Alabama State Port Authority
Addendum to R&P or Specification Booklet

Project Name Pit and Roof Extension TASD Diesel Shop

Project No. 11407 **Task No.** 02 **Addendum No.** 2

The following items are clarifications to questions received. These items are hereby included in the bid documents by this addendum.

DRAWING NUMBER
4503-F4

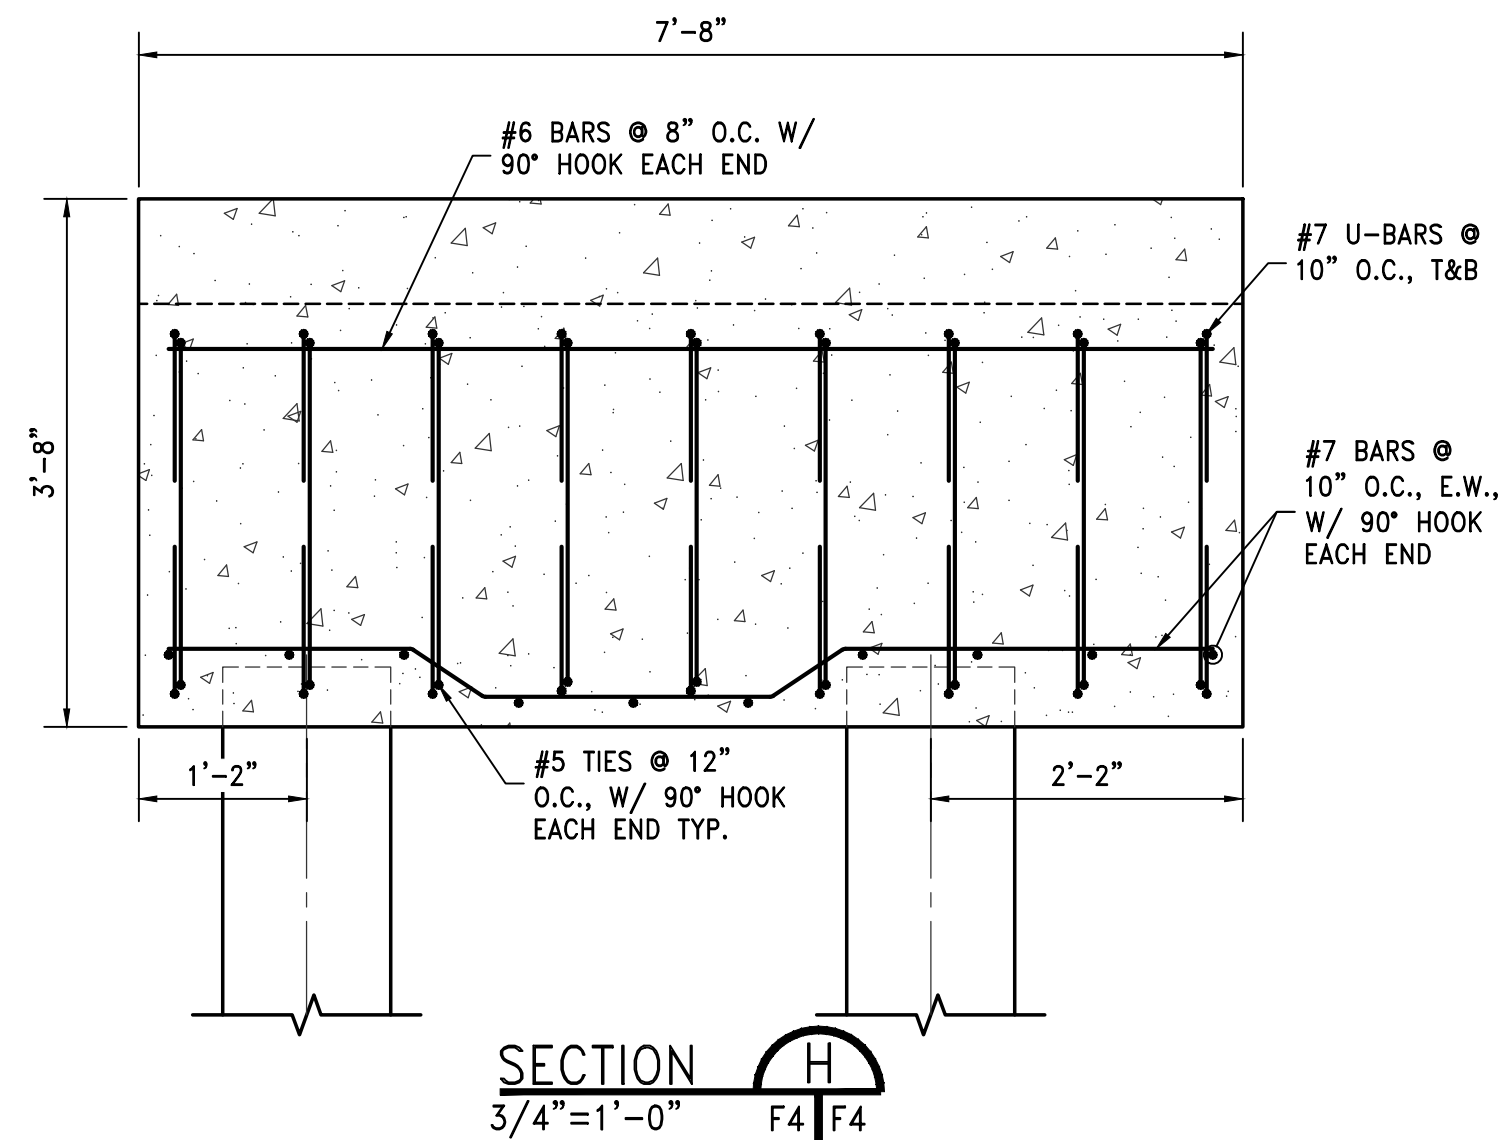
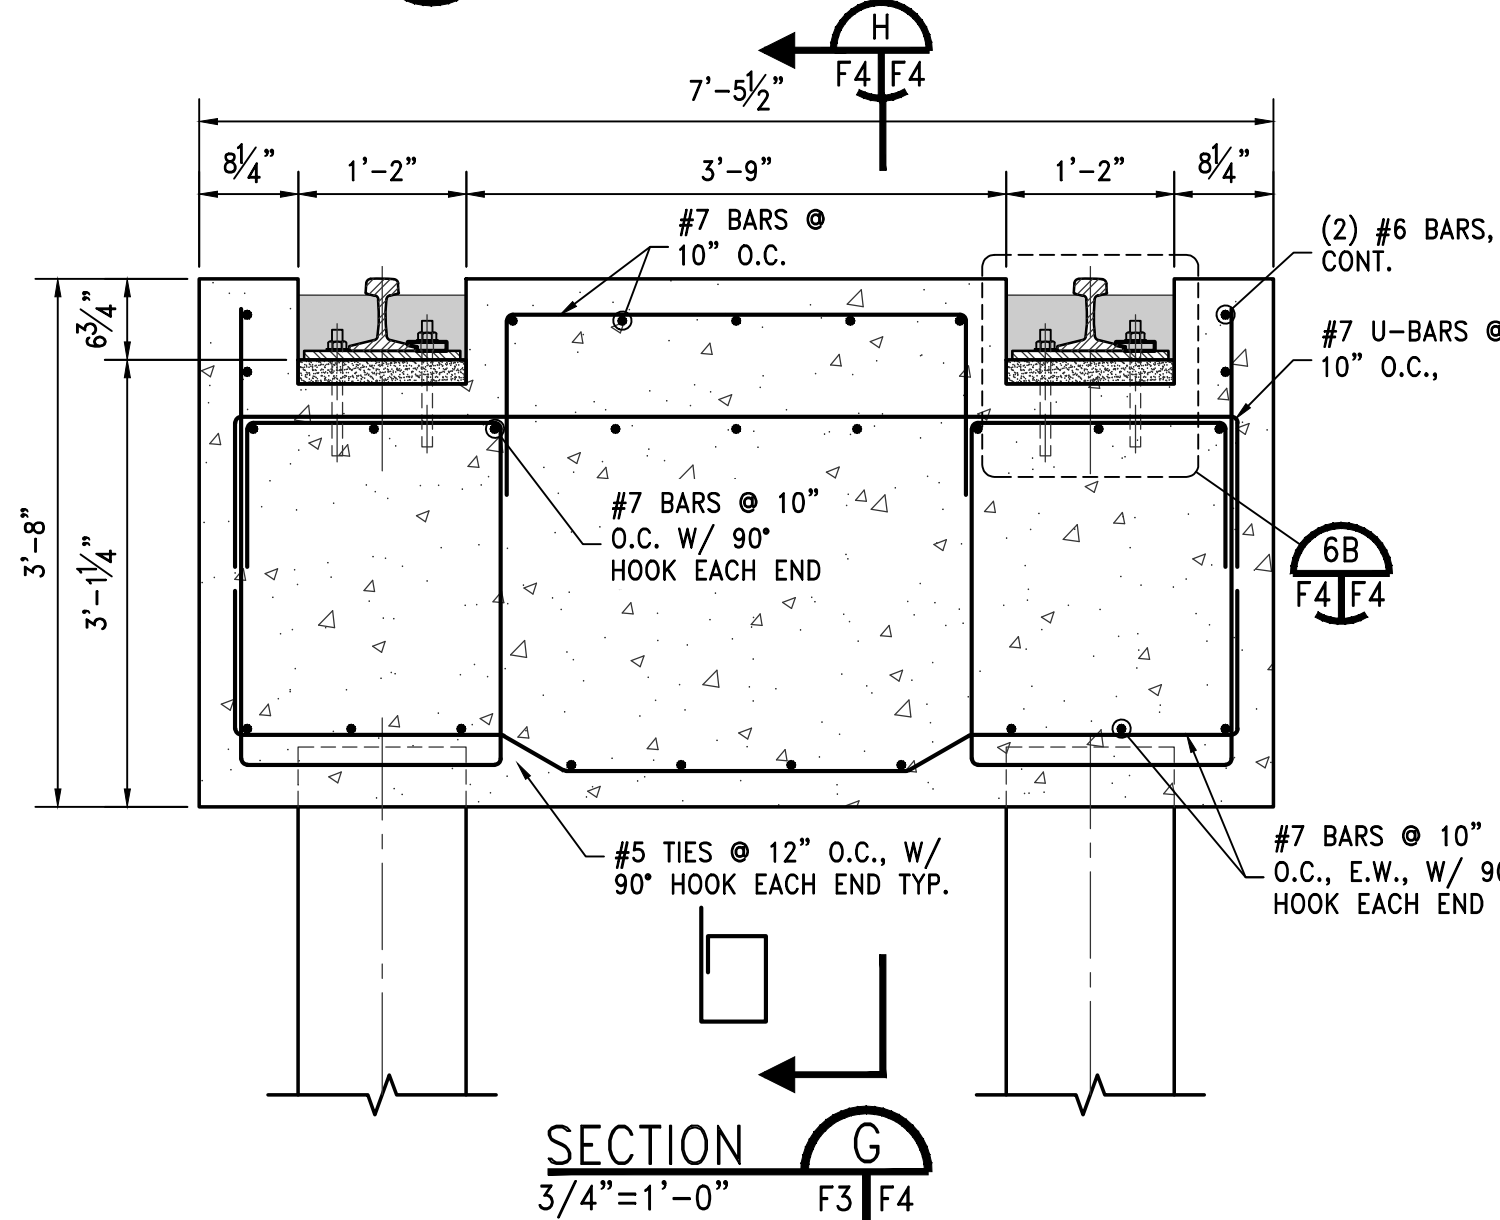
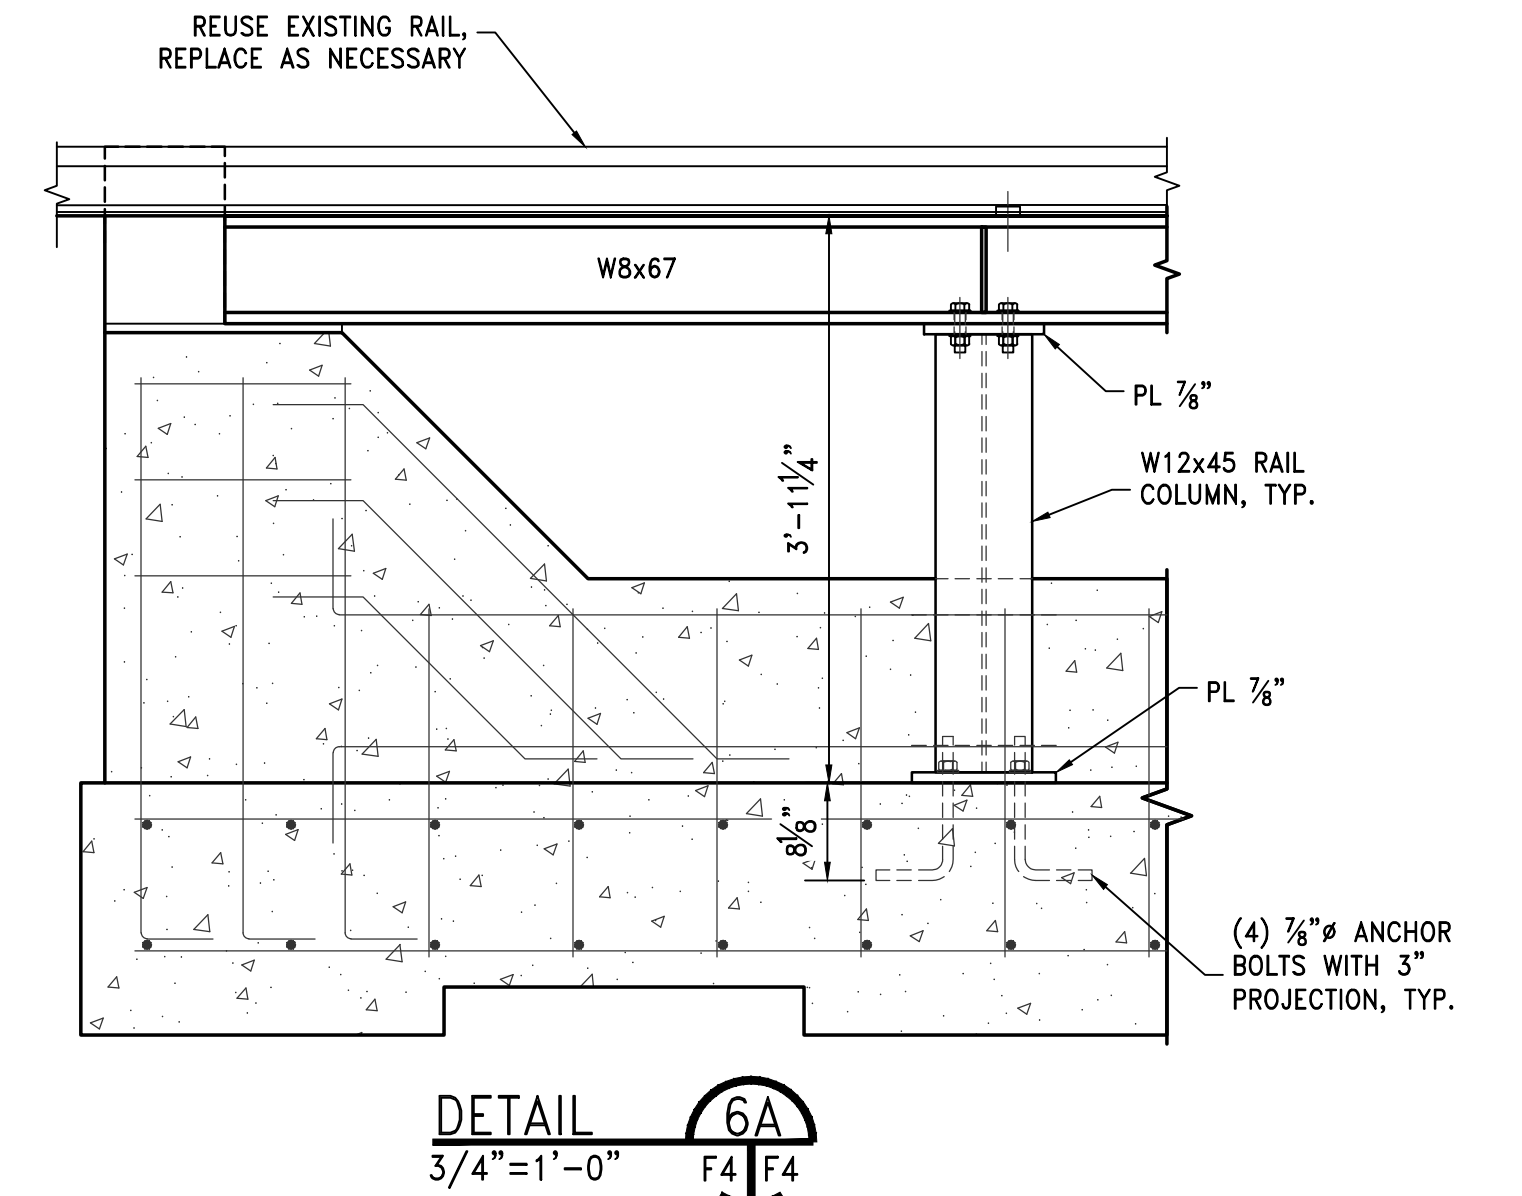
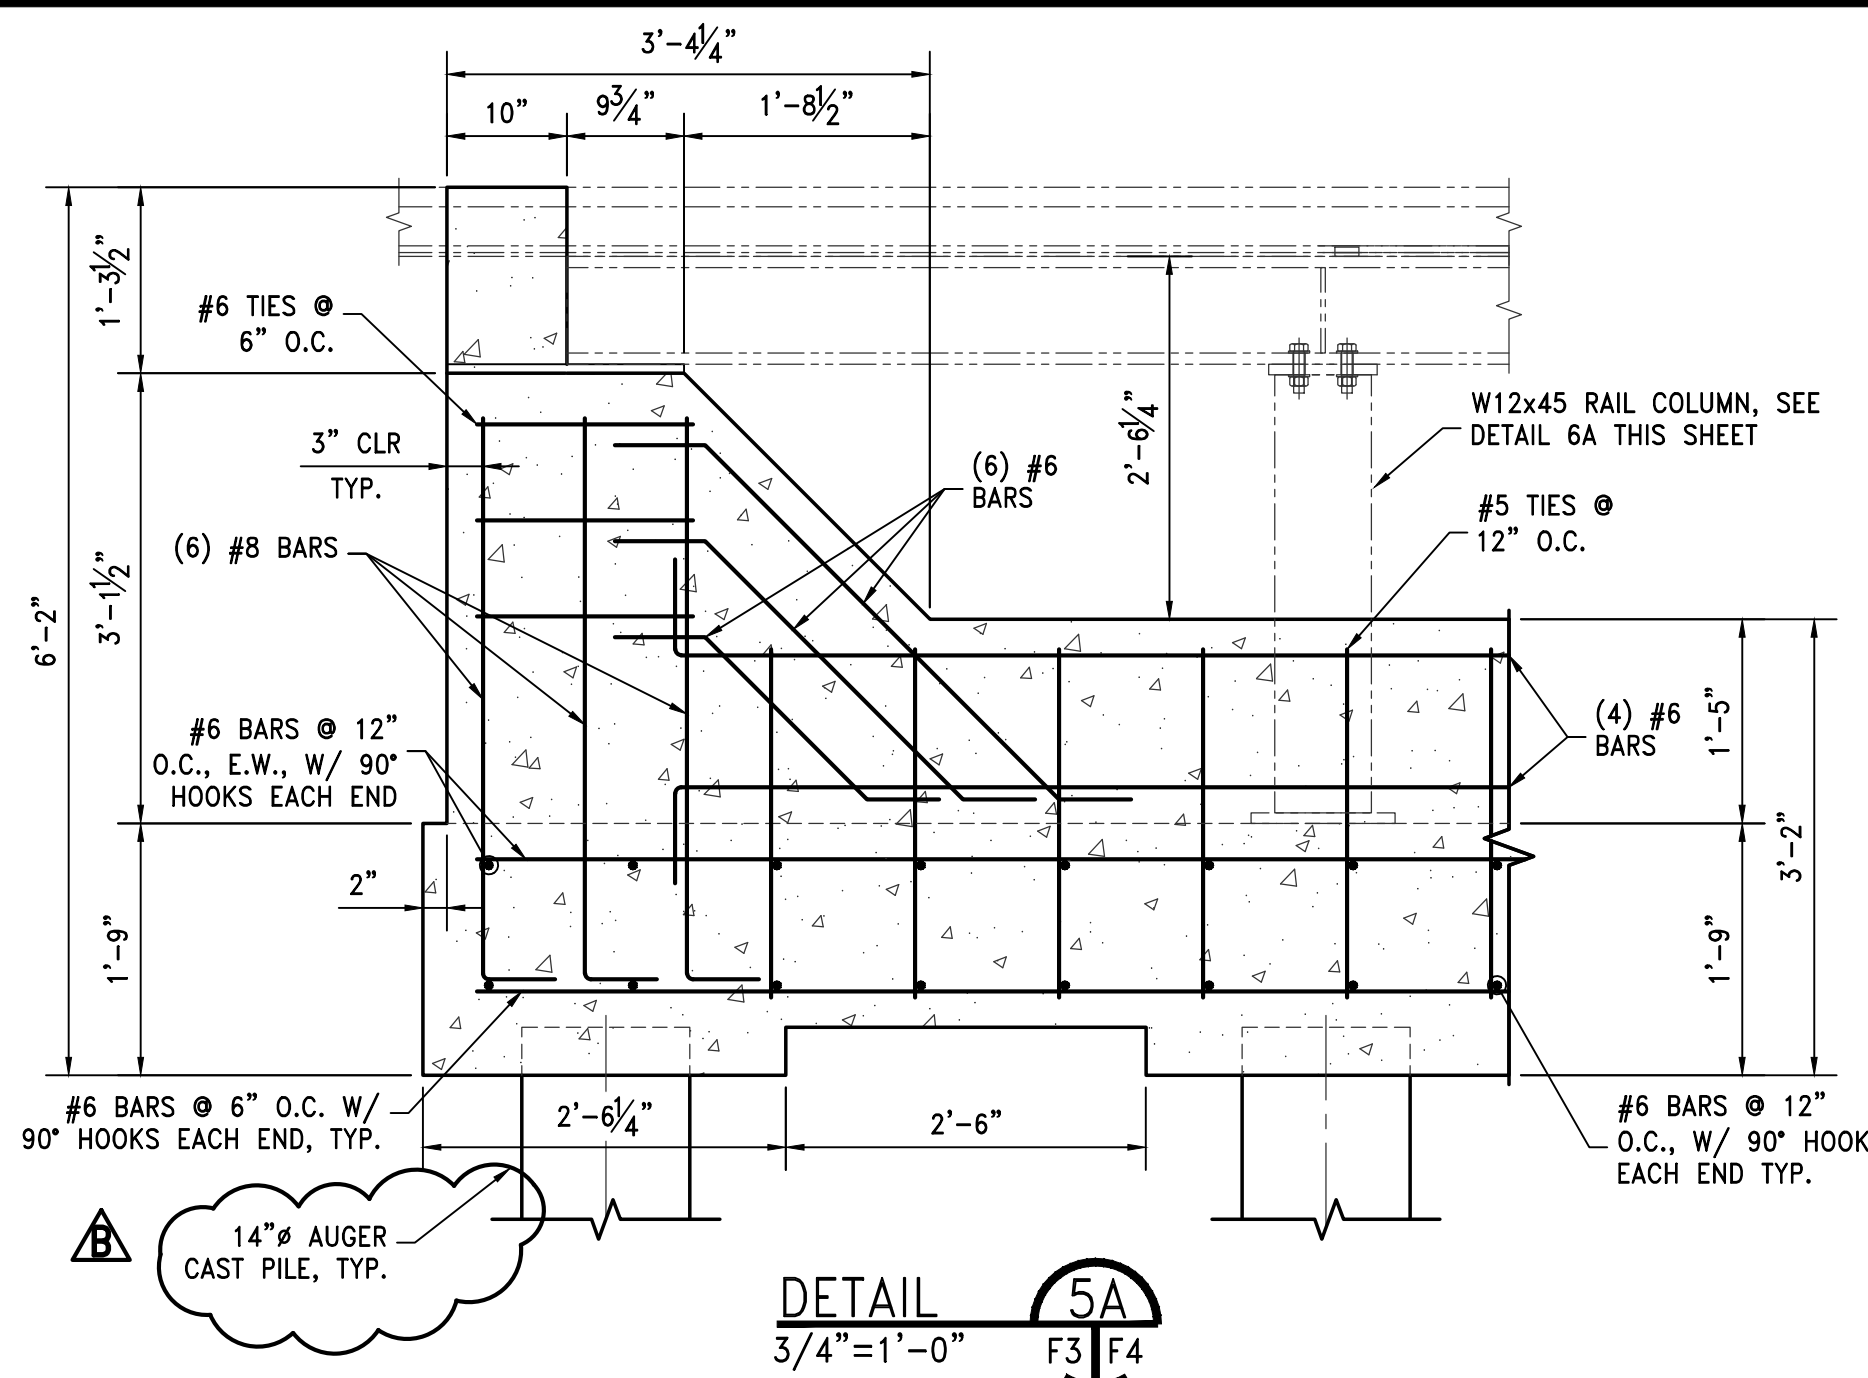
5.	<p>Question: Can you confirm that there are no 16" piles on the project? The pile details show both 14" and 24" piles, but there is one callout for 16" in drawing 4503-F4 detail 5A.</p> <p>Answer: There are no 16" piles on the project. Only 14" and 24". See revised 4503-F4.</p>

10.	<p>Question: Could you please provide a Geotech report?</p> <p>Answer: Yes, the Geotech report will be provided to all prospective bidders.</p>
11.	<p>Question: The Enlarged Foundation Plan of the pit area as shown on drawing 4503 – F3 seems to show (8) pilings having a larger diameter than 14" as scaled on Detail G/F4. These piling scale 16" diameter, however there is no detail for a 16" diameter auger cast pile. Detail 5A/F4 calls for a 16" diameter pile at the location shown on detail F/F3 as a 14" Diameter pile. Section E/F3 identifies (4) piles as 14" diameter at the location shown on detail A/F4 as 24" diameter piles. Please clarify.</p> <p>Answer: There are no 16" augercast piles. The larger piles called out as 14" on 4503 – F3 should be 24" diameter -See addendum 1, revised 4503-F3. On Section E, the piles supporting a cap with a 4'-0" pedestal are 24" diameter. See revised 4503-F4.</p>
